In the Drawings:

REMARKS:

Gerald Harron et al
Originally filed Sheet 1 of 6
Battison - 85195-402 ADB

FIGURE 1

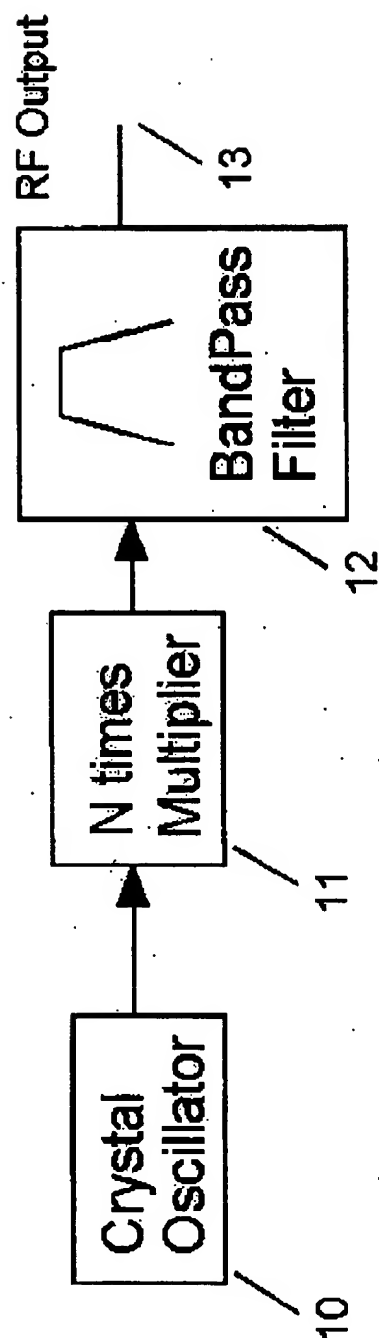
Figures 1 through 4 have been amended as requested by the Examiner to include the words "Prior Art".

Figures 1 through 4 have been amended as requested by the Examiner to include the words "Prior Art".
